**CITY PLAN COMMISSION****THURSDAY, MAY 2, 2024****FILE NUMBER:** S234-080**SENIOR PLANNER:** Sharmila Shrestha**LOCATION:** Executive Drive at Northwest Highway/ State Highway Spur No. 244, northeast corner**DATE FILED:** April 3, 2024**ZONING:** CS**CITY COUNCIL DISTRICT:** 9**SIZE OF REQUEST:** 3.417-acres**APPLICANT/OWNER:** City of Dallas**REQUEST:** An application to create one 3.417-acre lot from a tract of land in City Block D/8043 on property located on Executive Drive at Northwest Highway/ State Highway Spur No. 244, northeast corner.**SUBDIVISION HISTORY:**

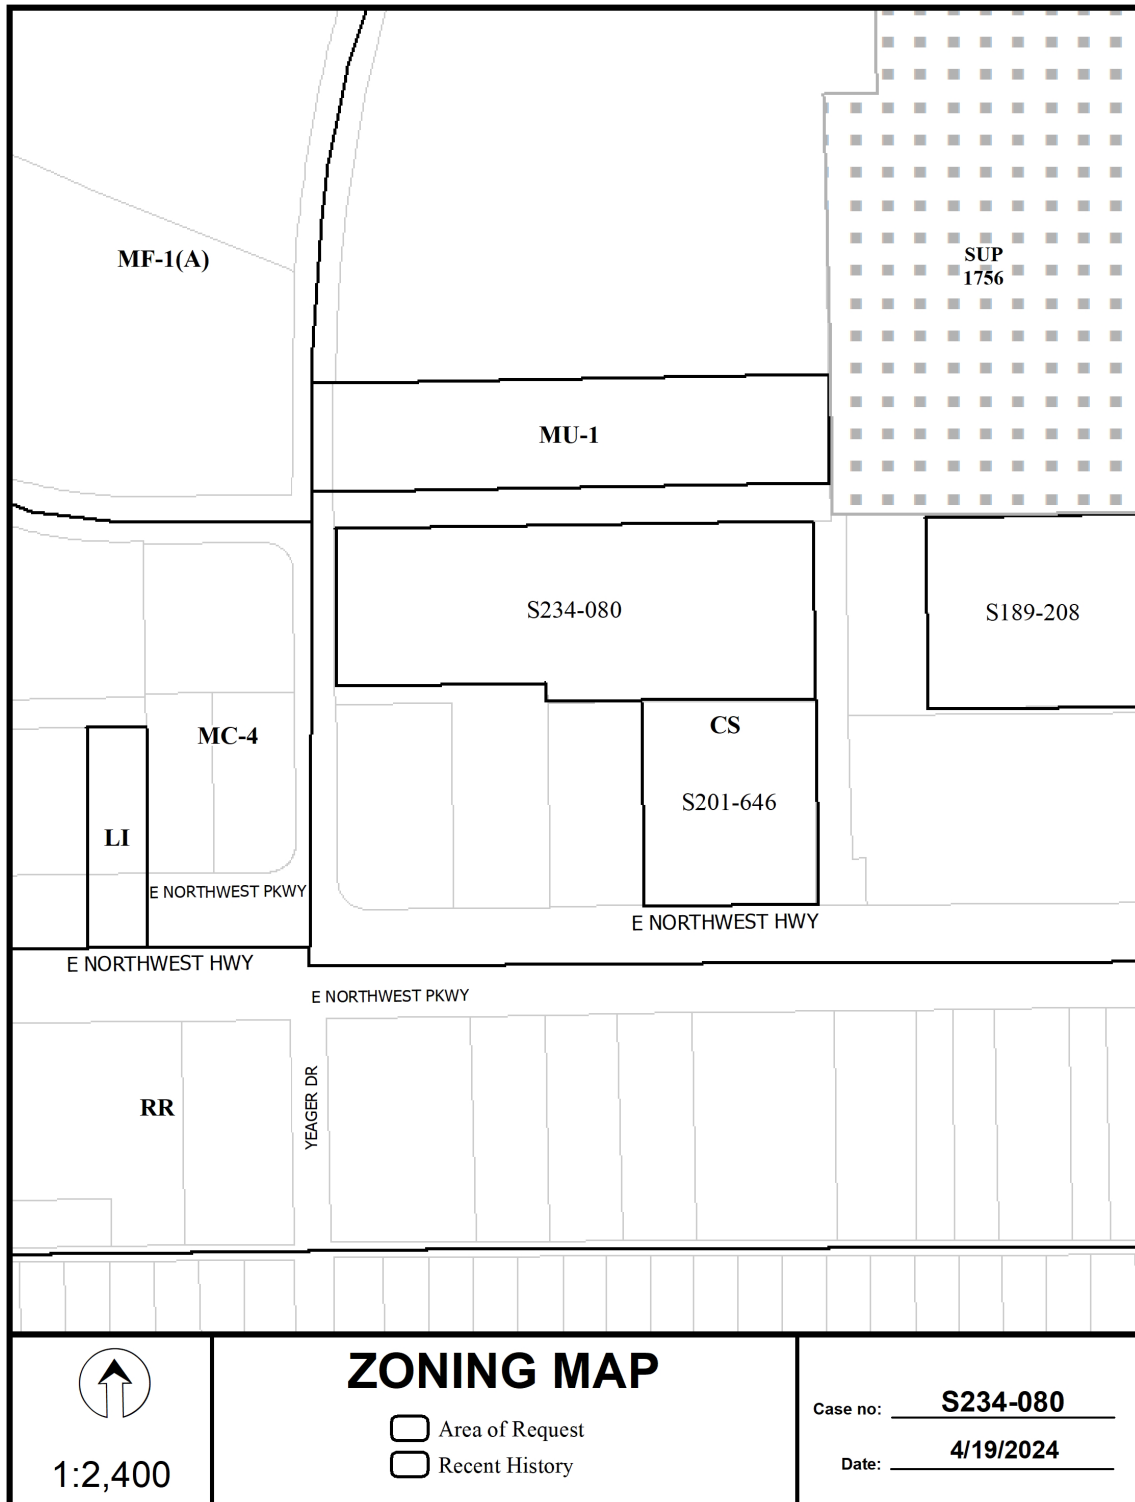
16. Prior to final plat, submit a completed final plat checklist and all supporting documents.
17. On the final plat, show how all adjoining right-of-way was created. Section 51A-8.403(a)(1)(A)(xxii).
18. On the final plat, show distances/width across all adjoining right-of-way.

19. On the final plat, show all additions or tracts of land within 150 feet of the property with recording information.

20. Additional design information is required for assessment. Site plan must be submitted showing proposed development, building finished floor elevation, development, existing mains – including downstream manhole, and proposed water and wastewater service locations. Submit water/wastewater engineering plans to 320 E. Jefferson Blvd., Room 200, Attention: Water and Wastewater Engineering.
21. Water and wastewater main improvements may be required by Private Development Contract. Submit water/wastewater Engineering Plans to 320 E. Jefferson Blvd., Room 200, Attention: Water and Wastewater Engineering.

22. On the final plat, change “Northwest Highway” to “Northwest Highway/ State Highway Spur No. 244”.
23. On the final plat, identify the property as Lot 8 in City Block D/8043.
